PLANT NAMES: Kewaunee Plant

Subject; Request for Additional Information
Your Letter of October 4, 1972

CONTAINMENT PRESSURE RESPONSE TO LOCA

COMPARTMENT DIFFERENTIAL PRESSURE ANALYSIS

Figure -6
Double Ended Crossover Break

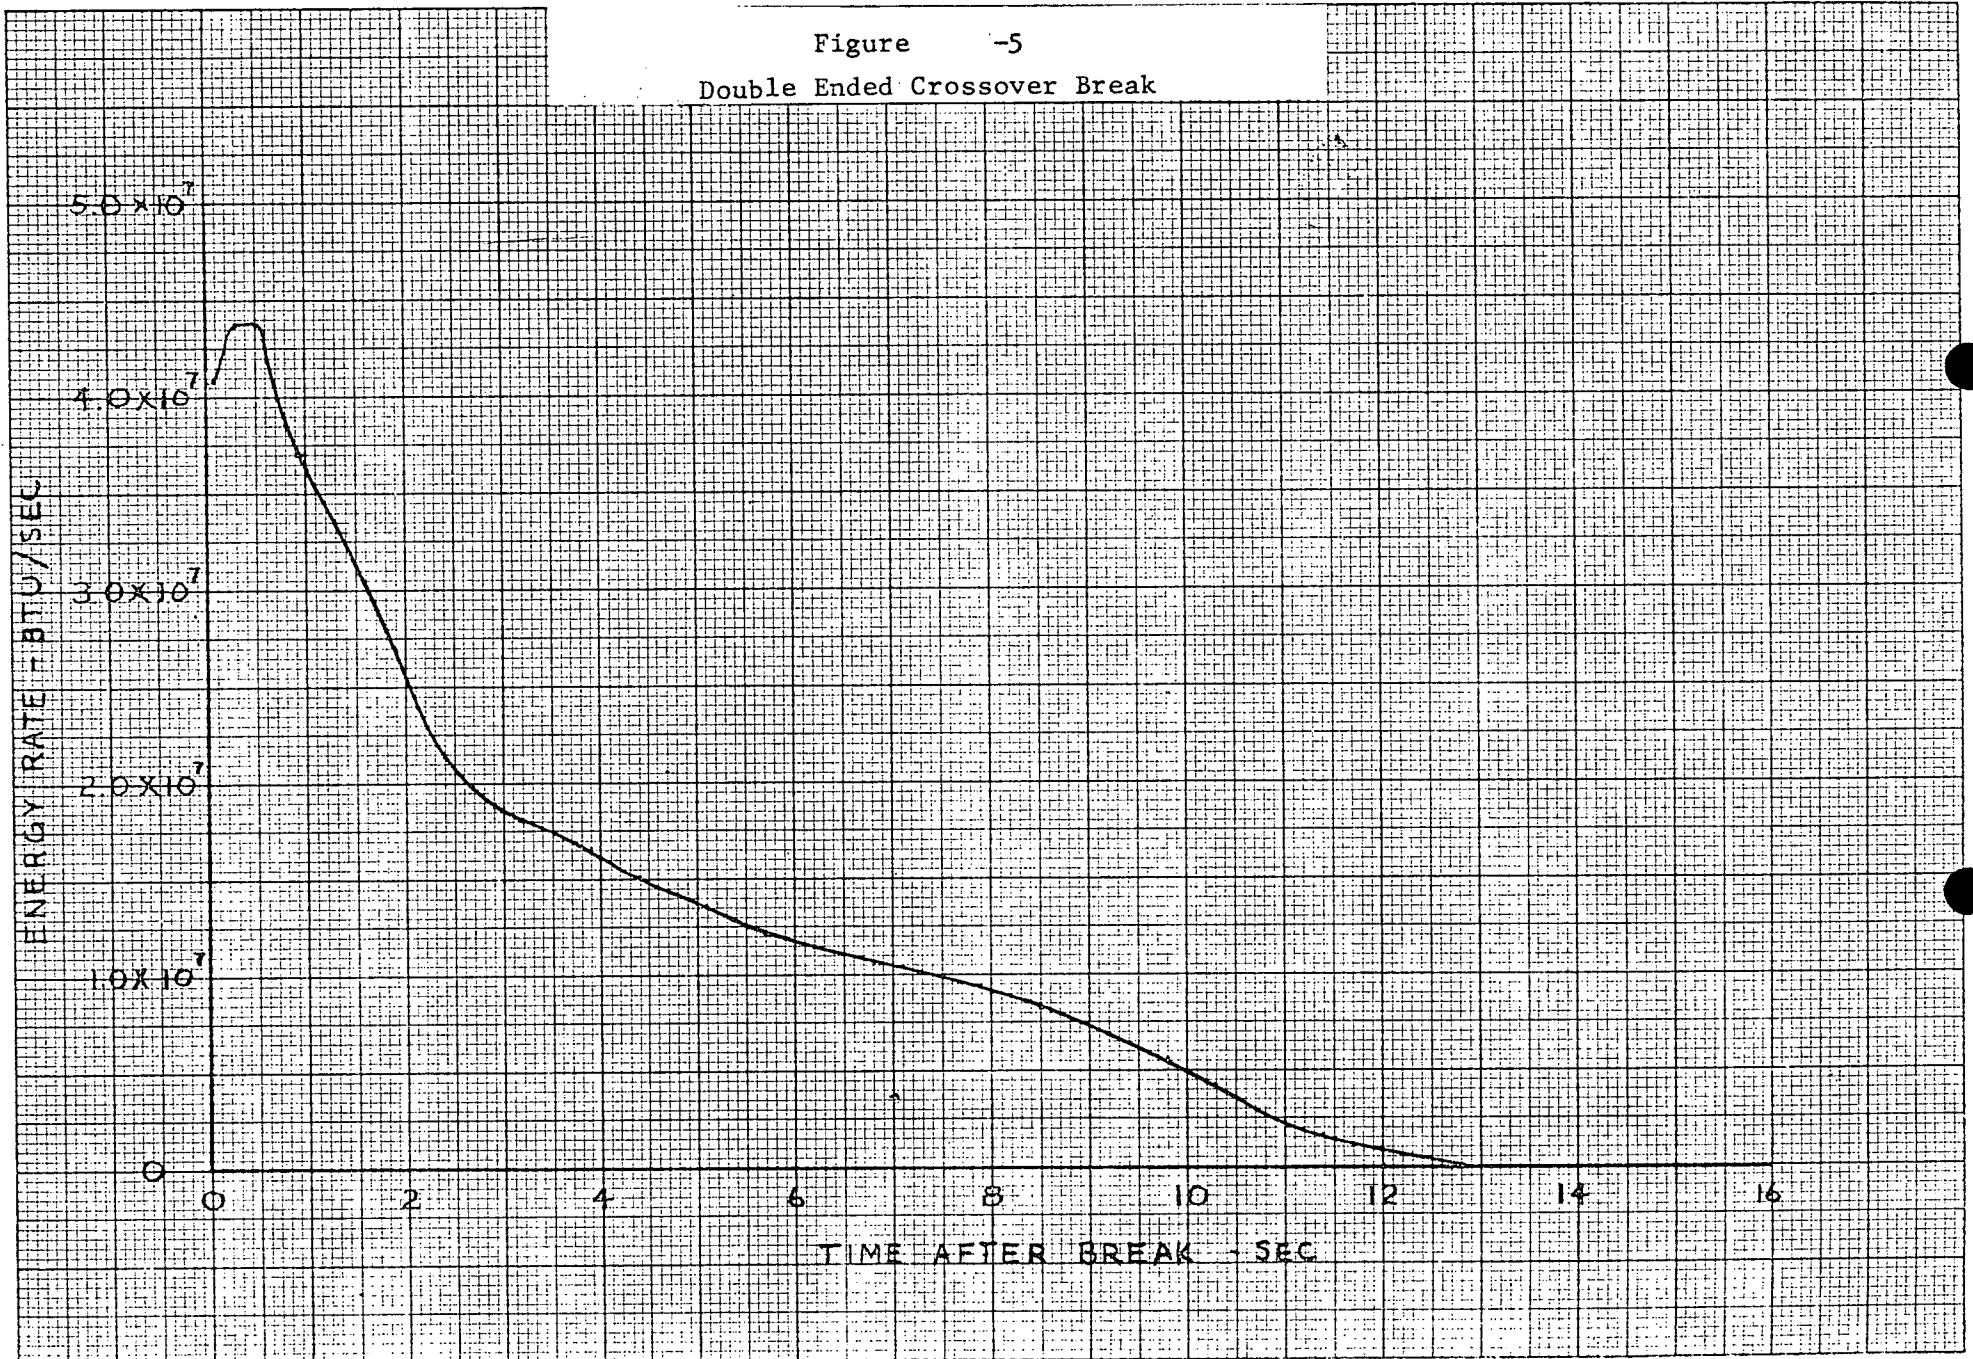
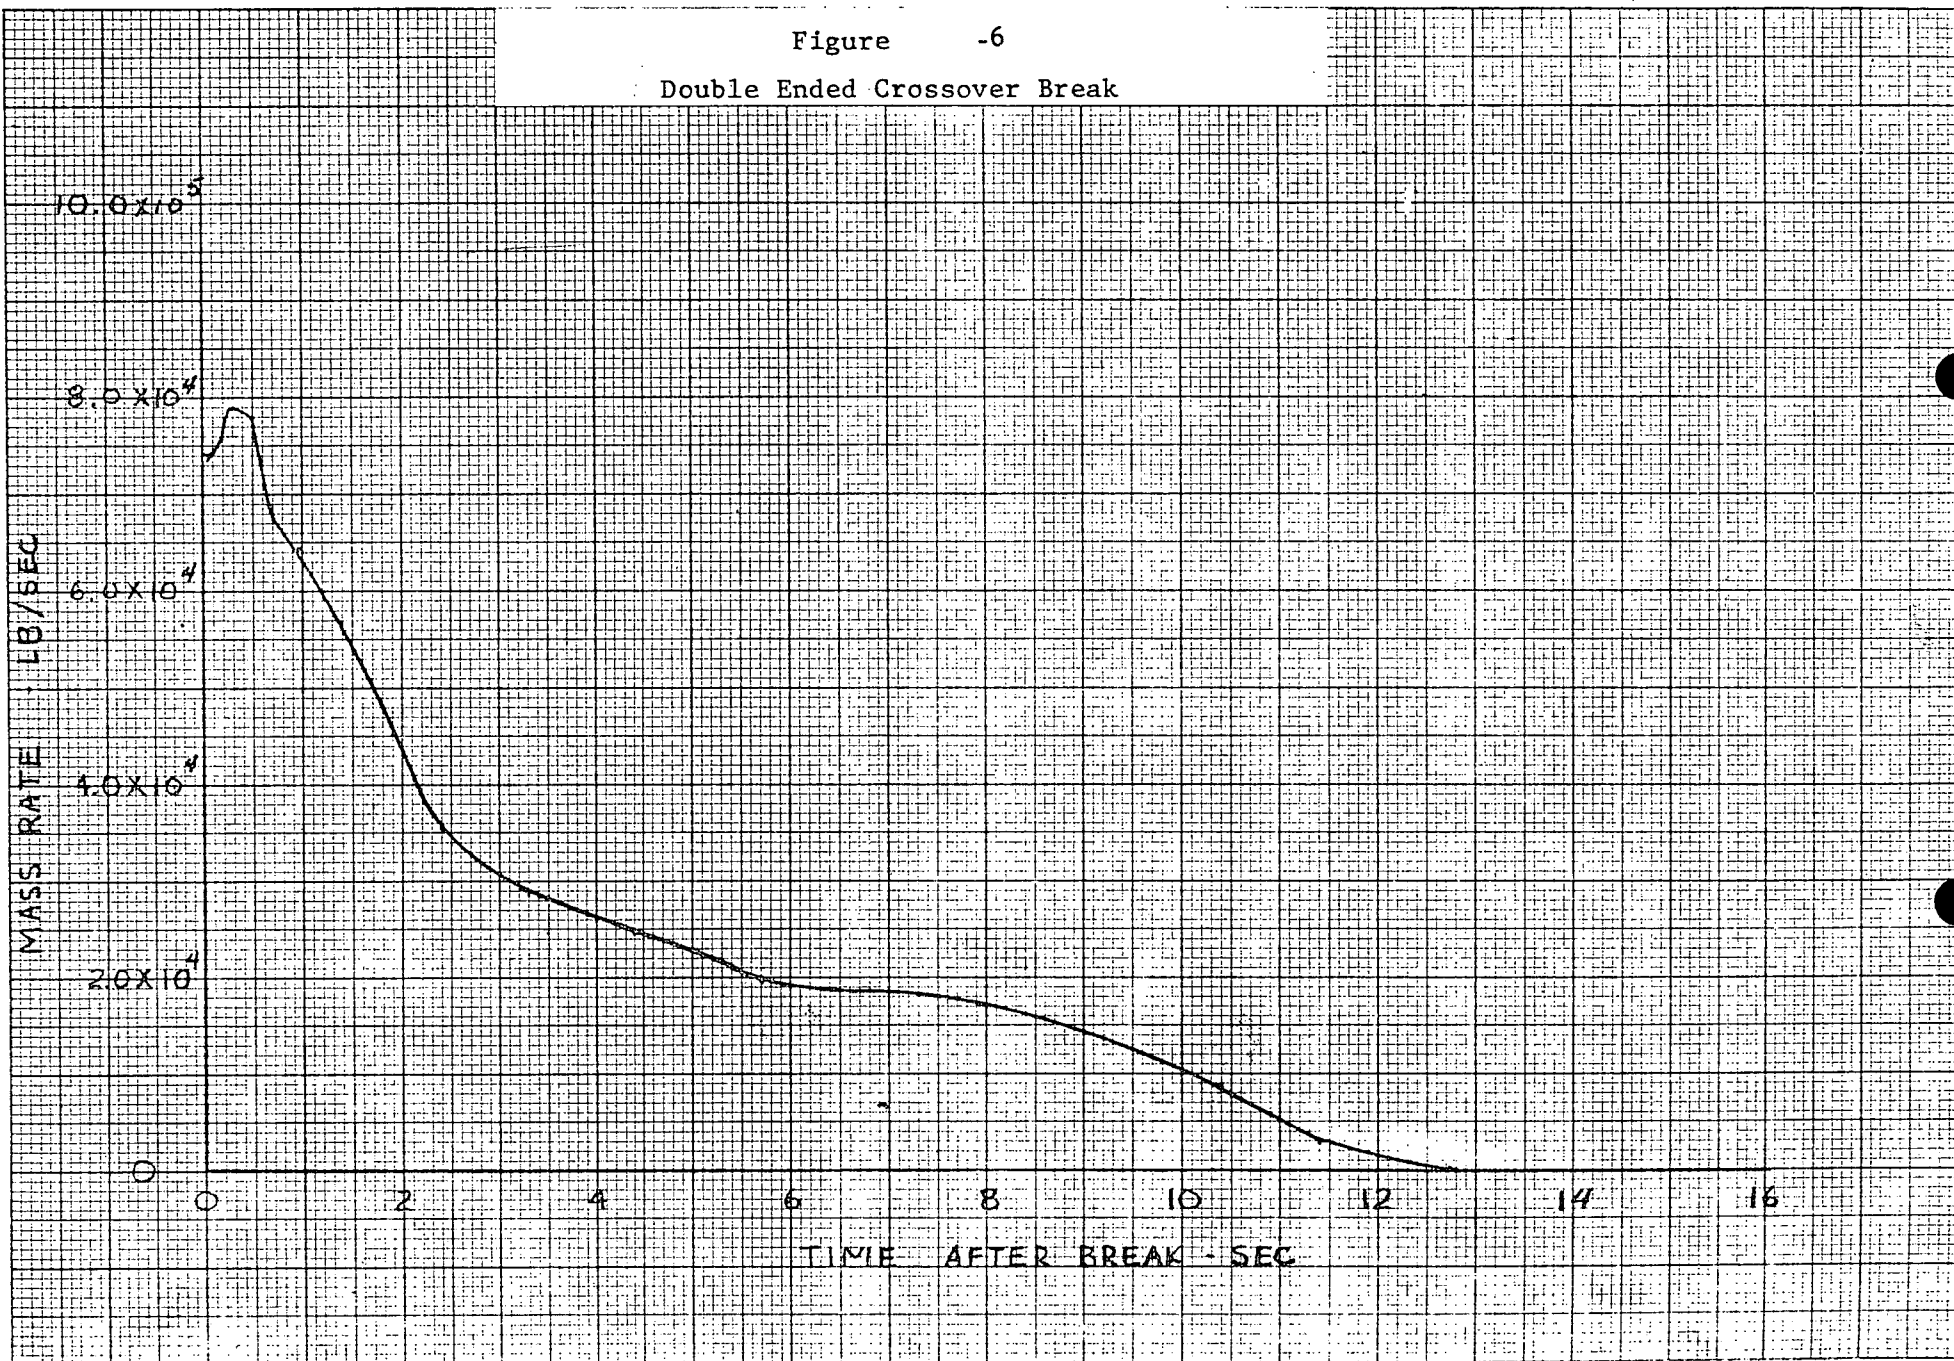
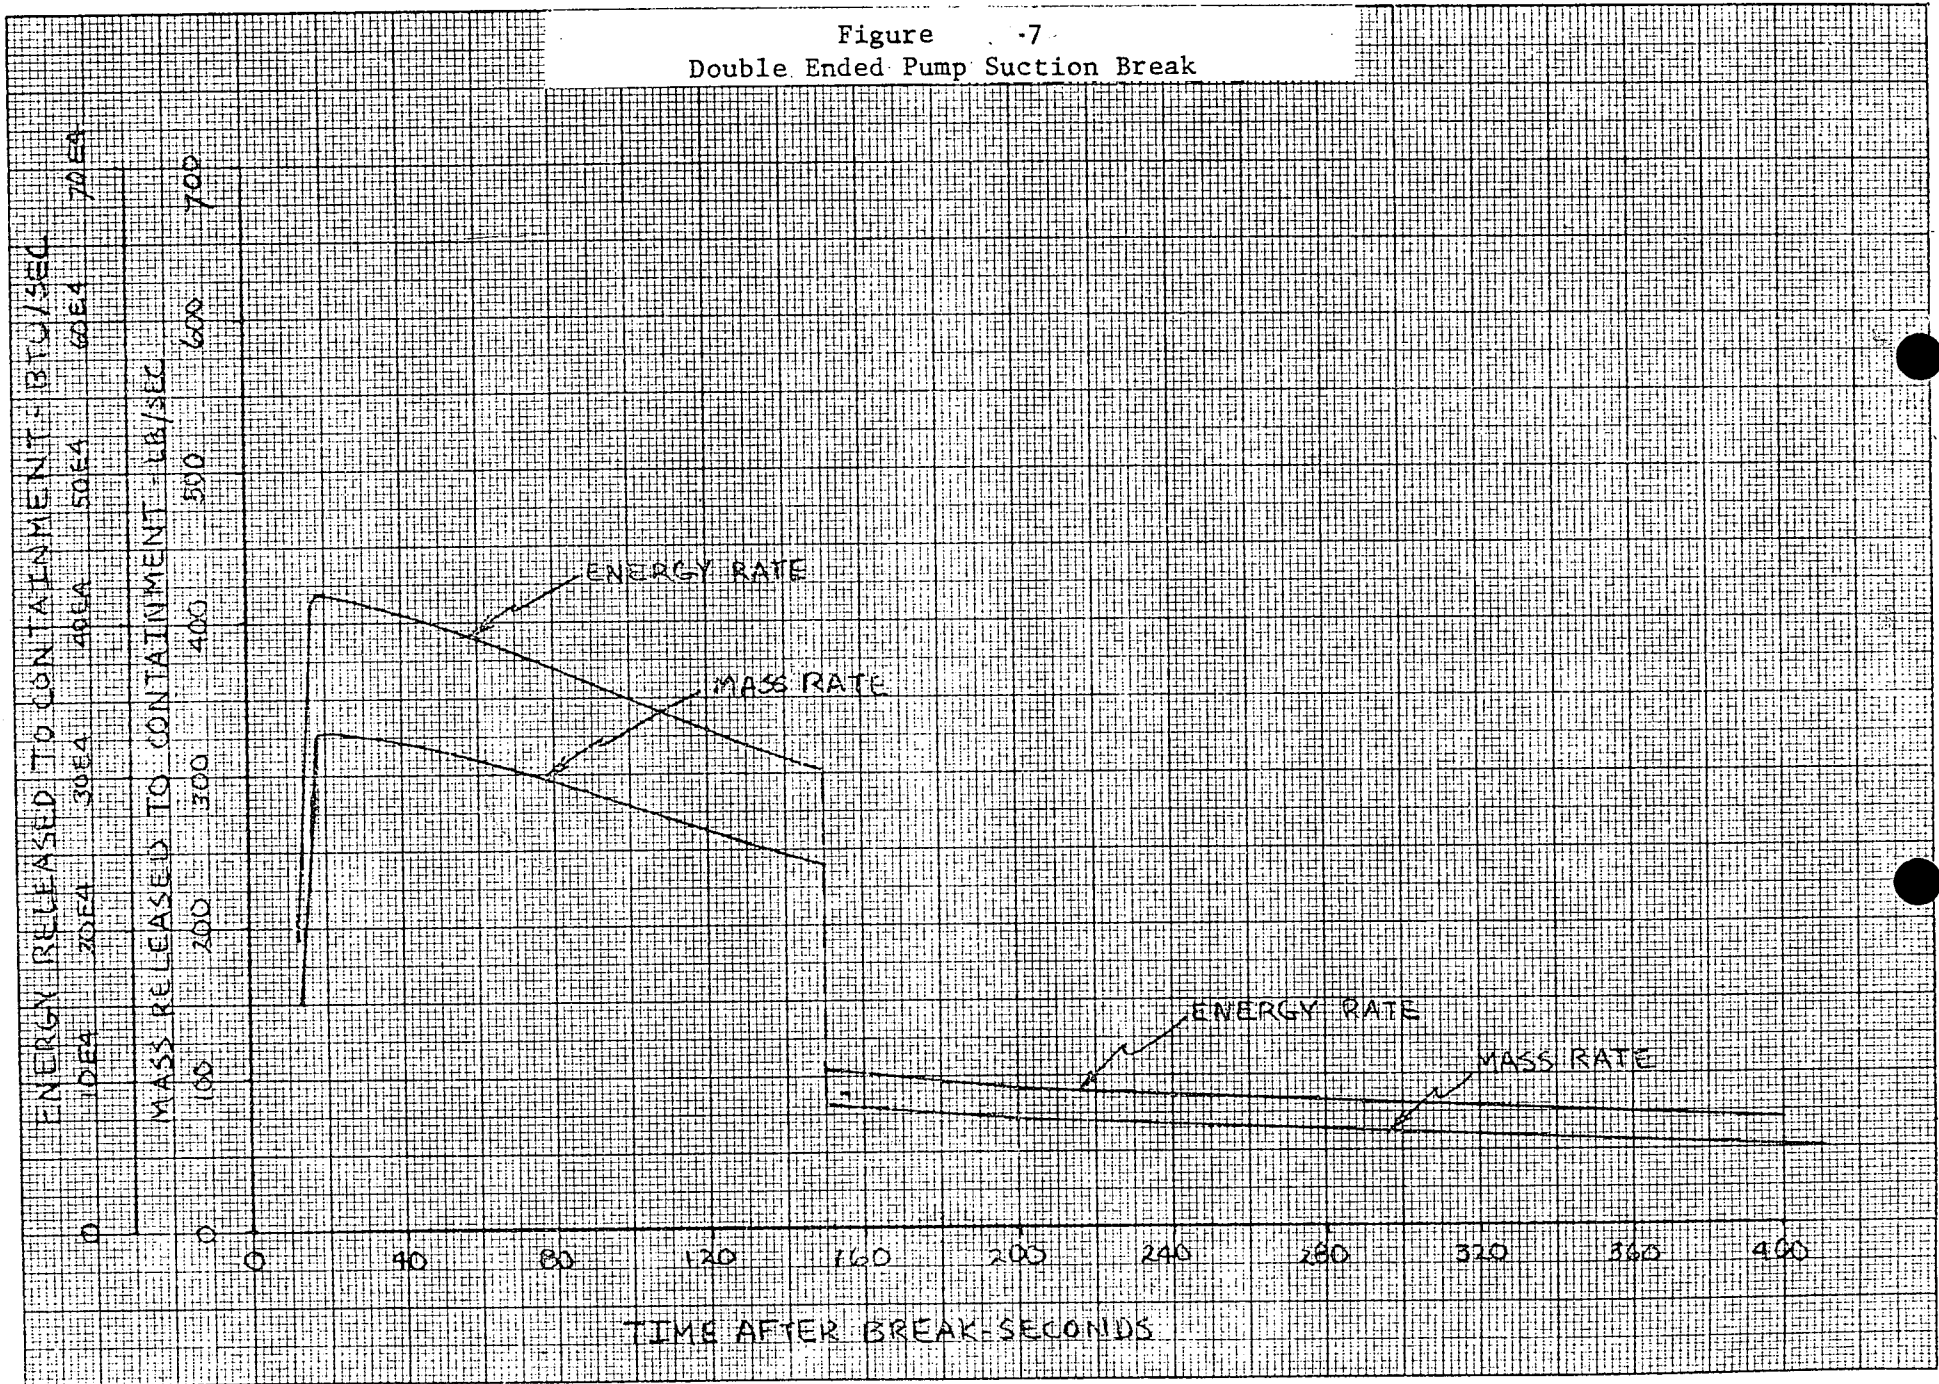
For the cold leg break, the size and location resulting in the highest calculated containment pressure analyzed in Item 1, tables of mass release (pounds/second), the enthalpy of the mass (BTU/pound) released from the core, and the mass and enthalpy released to the containment should be provided throughout the blowdown and reflood phases of the accident. A graph showing core inlet velocity as a function of time should also be provided for the reflood phase of the accident.

The analysis described above has been performed. The mass and energy released to the containment as a function of time is given in Figures 5, 6 and 7. This results in the containment pressure transient given in Figure 9. For this case the core inlet velocity as a function of time after bottom of core recovery is given in Figure 8. The peak pressure for the design case is 42.7 psig.
